Peter E. Katz
Vice President
Calvert Cliffs Nuclear Power Plant
Constellation Generation Group, LLC

SUBJECT: Calvert Cliffs Nuclear Power Plant
Unit Nos. 1 & 2; Docket Nos. 50-317 & 50-318
License Amendment Request: Revisions to the Refueling Operations Section of
the Technical Specifications

MARKED UP TECHNICAL SPECIFICATION PAGES

SDC and Coolant Circulation-Low Water Level
3.9.5

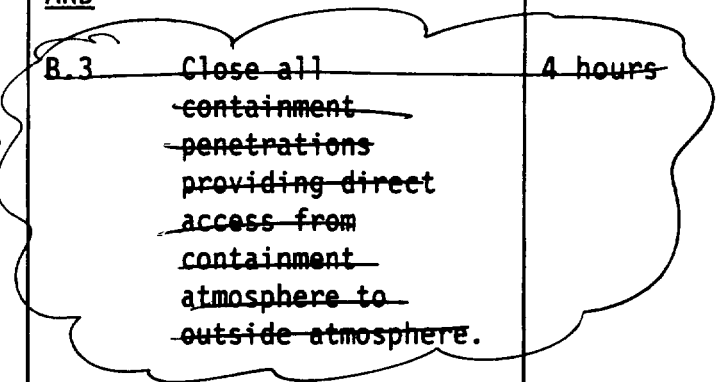
| CONDITION | REQUIRED ACTION | COMPLETION TIME |
|--|--|--------------------|
| | B.3 Close all containment penetrations providing direct access from containment atmosphere to outside atmosphere. | 4 hours |

Insert 3

Insert 3

B.3.1 Close equipment hatch and secure with a minimum of four bolts, 4 hours

B.3.2 Close the containment outage door.

B.4 Close one door in each air lock. 4 hours

B.5.1 Close each penetration providing direct access from the containment atmosphere to the outside atmosphere with a manual or automatic isolation valve, blind flange, or equivalent. 4 hours

B.5.2 Verify each penetration is capable of being closed by an OPERABLE Containment Purge Valve Isolation System. 4 hours
